INSTRUCTION TO SERVICE

ITS61748		05/22/2026
SECTION:	470-Destination Signs	
SUBJECT:	Torque mounting hardware on front destination sign	
ISSUE:	Hardware is not torqued on front destination sign.	
SUMMARY:	Torque hardware to 60 IN/LBS.

Figure 1: Location of the front destination sign

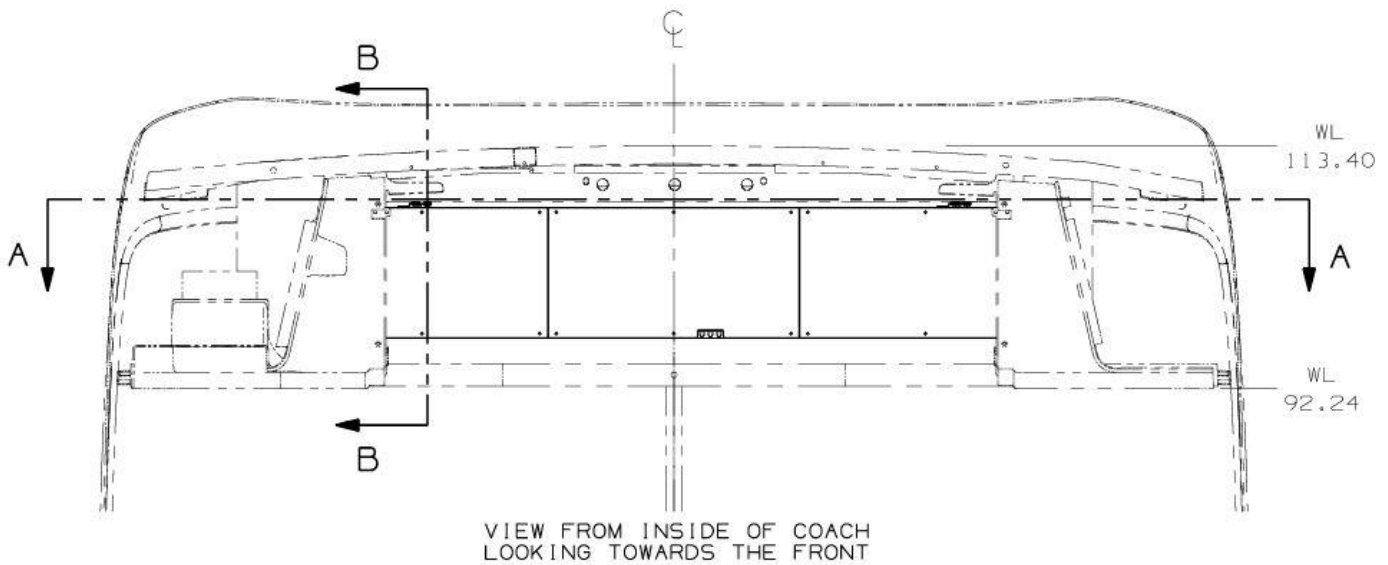
1. Set Park brake.
2. Turn the main battery disconnect switch to the “OFF” position.
3. Locate the front destination sign in the upper front compartment in the bus. For steps 3 & 4, see Figure 1.
4. Loosen off side mounted bolts on the front destination sign. Re-tighten hardware and torque to 60 IN/LBS.
Repeat application on the 3 remaining bolts.

Figure 1a: Torque hardware as per note 5.

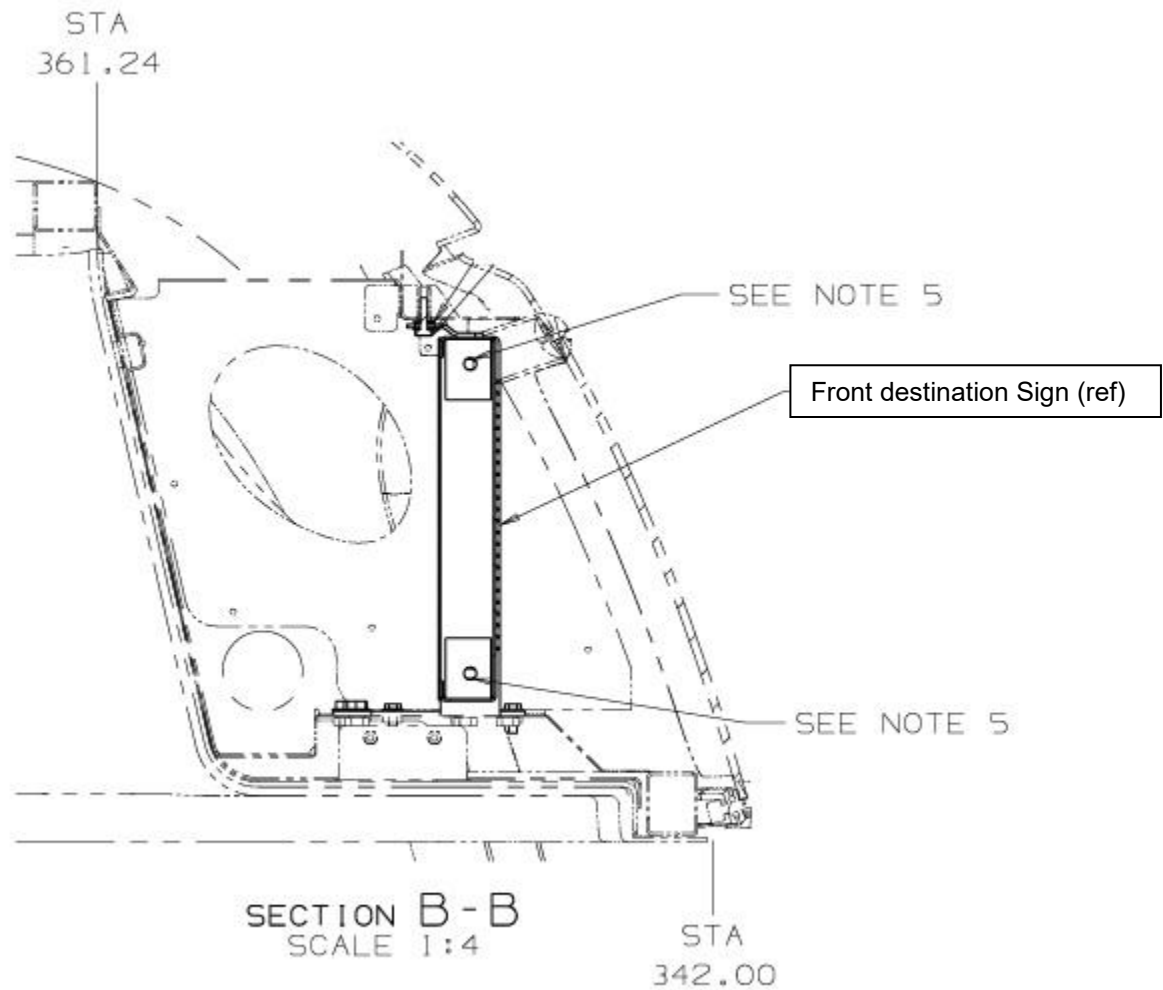
5) TORQUE VENDOR SUPPLIED HARDWARE TO 60 IN/LBS
